Stage 1/2 Road Safety Audit

Proposed school's development at Clondalkin, Co. Dublin December 5th 2016

1. Site Layout Plan

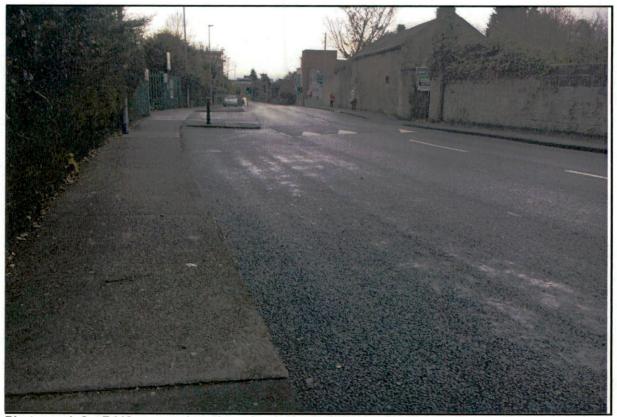
The audit team have noted that the proposed plans provided do not have any directional, information signage or road markings included to provide the necessary information to road and vulnerable road users as how to use the internal road network. There are obvious safety risks associated with a lack of internal information associated with the infrastructural network resulting in possible collisions, risks to pedestrians and confusion for all during peak times.

The audit team note that it is not clear from the plans provided as to the extent of set down and parking areas along the internal road network. There are potential safety risks if motorists do not understand the set down areas provided resulting in possible collisions with pedestrians and other vehicles.

The audit team have concerns regarding the proposed tight 90-degree internal bends within the campus. It is unclear from the plans provided if buses, emergency vehicles etc. will be able to safely navigate the layout, especially if vehicles are parked either side of the one way road.

It is noted that there are 3 areas designated for parking. It is unclear as to how these spaces are distributed for staff, parents and visitors. There is a potential safety risk of excess vehicular movements on site if insufficient information is provided for motorists entering the site who are unaware that there are additional car parking areas beyond the set down areas.

The audit team have noted from the plans provided that there are no details relating to the geometry of the internal road way and its width to accommodate traffic. There is a potential safety risk if the roadway is too wide or has no road markings for one-way traffic which could lead to unauthorised parking resulting in an increased safety risk.

The audit team note that while the main internal road system is designed for one-way traffic, there are a number of spur roads serving car parks and there is also an area to the rear of the existing school that will be two-way. It is unclear on the plans provided as to the information and road geometry available to ensure that two-way movements are possible and what measures will be provided to ensure that vehicles do not attempt to travel back along the one-way system in the wrong direction resulting in an increased safety risk.

It is recommended that the design team review their plans and provide details relating to the internal road network. It is recommended that the design team review the DMURS (Design Manual for Urban Roads and Streets) and the Traffic Signs Manual for guidance and details.

It is recommended that the design team review and update their plans to fully detail the extent of set down and parking areas provided along the internal link road within the campus.

It is recommended that the design team carry out an Autotrack analysis of the internal road network to ensure that all intended vehicles can safely access the internal road layout.

It is recommended that clear concise information signage is provided for motorists entering the site to ensure that they are aware of the parking area distributed throughout the school campus.

It is recommended that the design team provide more information for the internal road network to include all geometry, road signage and markings to ensure that road users use the proposed one-way system as safely intended.

It is recommended that the design team review their internal road layout provided and ensure that the internal road markings and signage is correctly provided to prevent any confusion on site.
